MY3 FINAL MONITORING REPORT
Hornpipe Branch Tributaries Mitigation Project
Lenoir County
Neuse River Basin
CU 03020202

RE: WLS Responses to NCDEQ DMS Review Comments for Task 9 Draft Monitoring Report Year 3 for Hornpipe Branch Tributaries Mitigation Project, NCDEQ DMS Full-Delivery Project ID #100076, Contract #7605, Neuse River Basin, Cataloging Unit 03020202, Lenoir County, NC

Hornpipe Branch Tributaries Mitigation Project Monthly Rainfall Summary

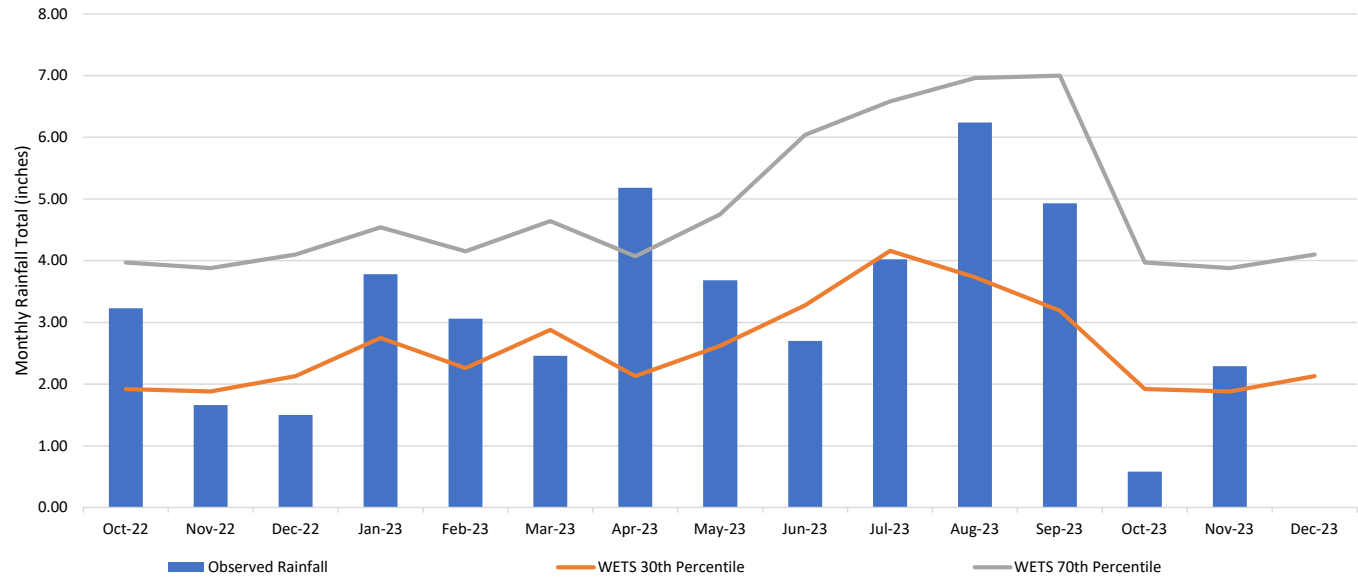
5. **Appendix D, Monthly Rainfall Summary Data: Based on the data for October 2023 rainfall was not normal; please update the table/graph. Please update with rainfall through November if possible.** WLS Response: WLS updated the October 2023 rainfall overall designation and added the rainfall total for November 2023 in the table and graph.

Flow Gauge Data – Hornpipe Branch Tributaries MY3

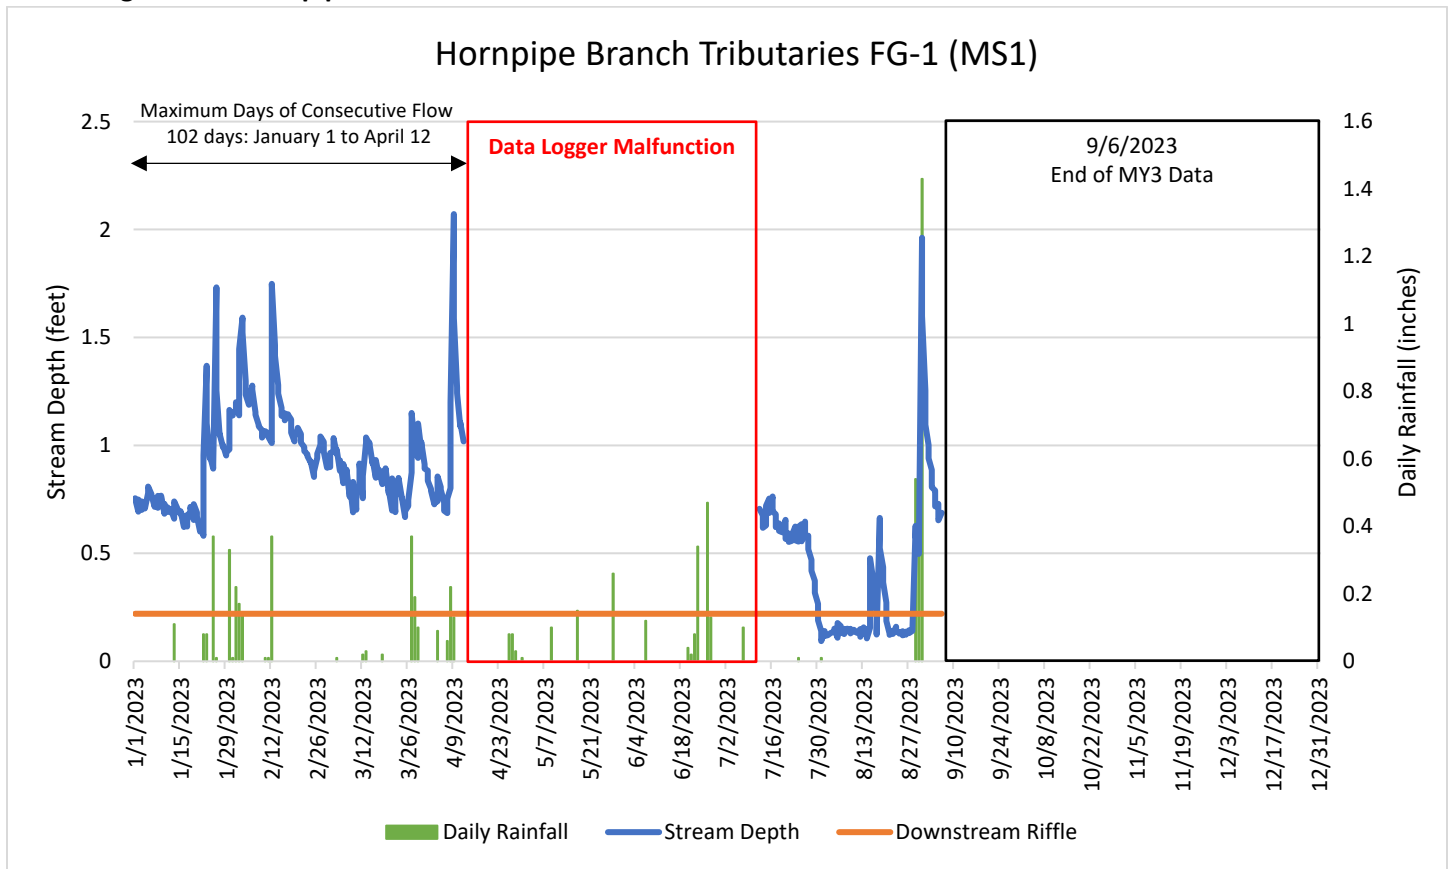
6. **Appendix D, Flow Gauge Data, FG-1 Graph: There is an error in the legend; please update.** WLS Response: The legend has been fixed on the FG-1 graph and updated in the report.

Hornpipe Branch Tributaries FG-3 (UT2)

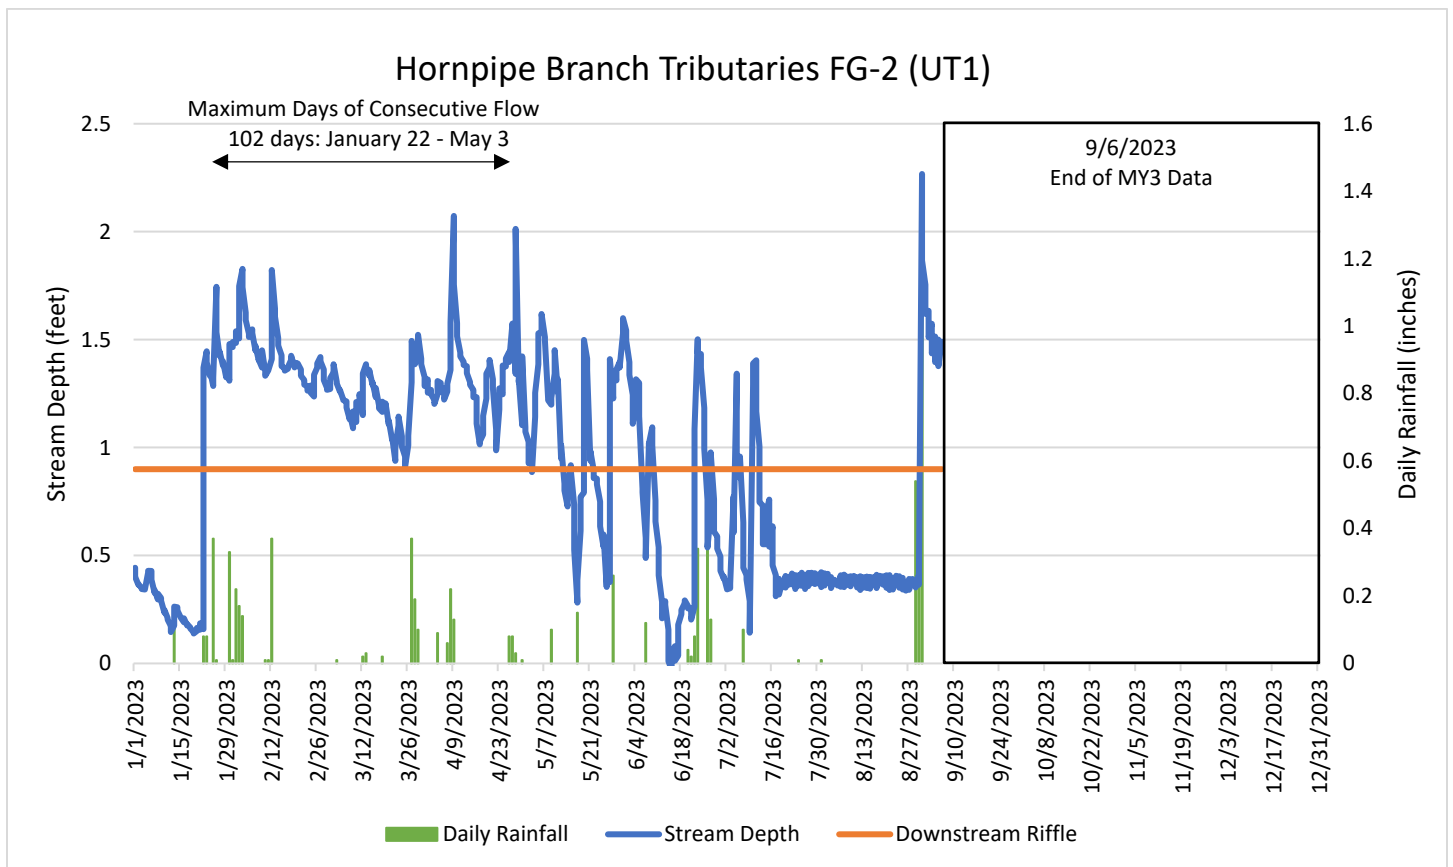
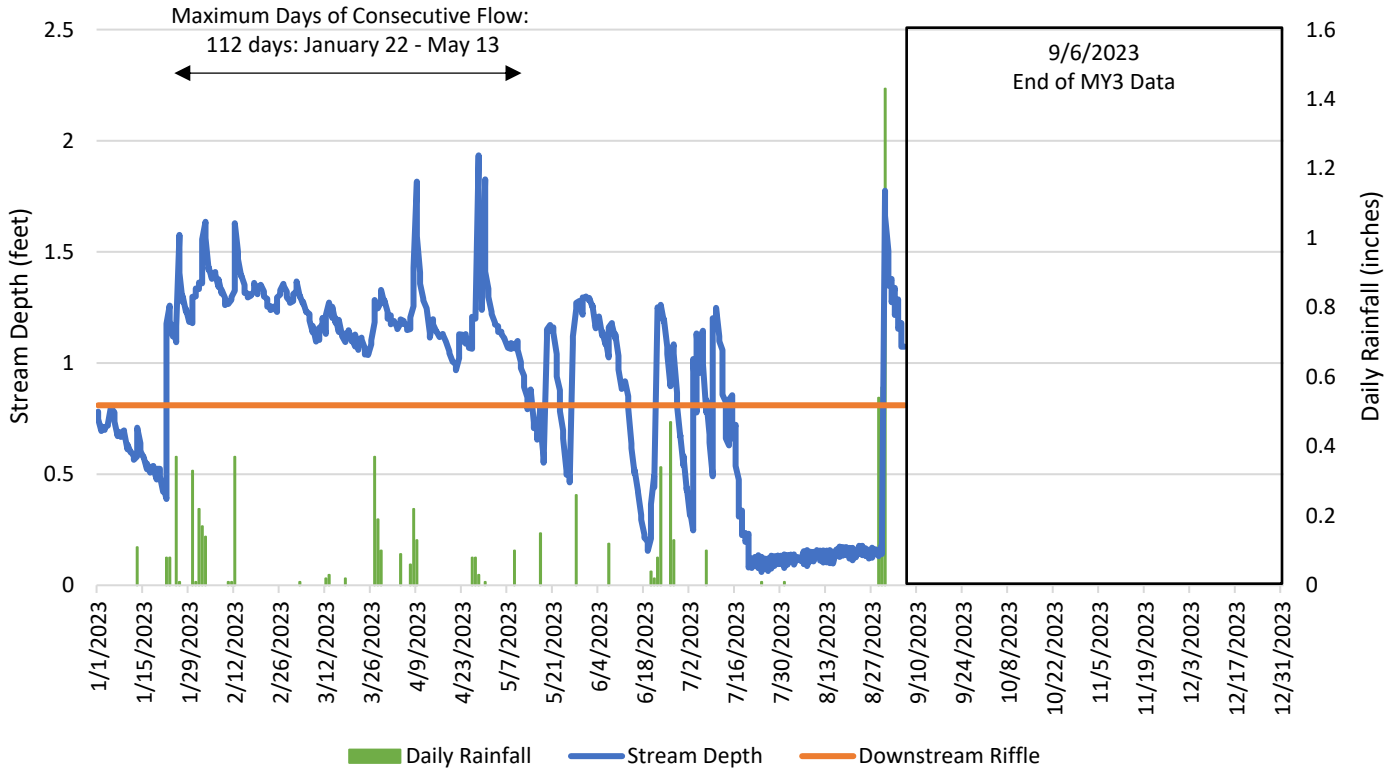
7. **Appendix D, Flow Gauge Data FG-2 & FG-3 Graphs: The arrows indicating max days of consecutive flow do not match the correct dates; please update.** WLS Response: The arrows on FG-2 & FG-3 graphs have been adjusted to match the correct consecutive flow days.
